Final Environmental Impact Statement

# Hampshire Country Club Planned Residential Development

Village of Mamaroneck, Westchester County,  
New York

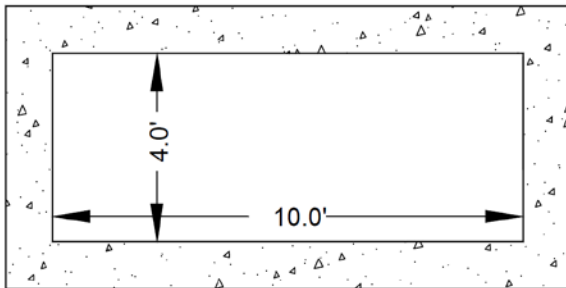
Proposed 100-year flowrate = 222 cfs

Assumed flow velocity = 6 ft/sec

$Q = AV$

$A = Q/v = 222/6 = 37 \text{ ft}^2$
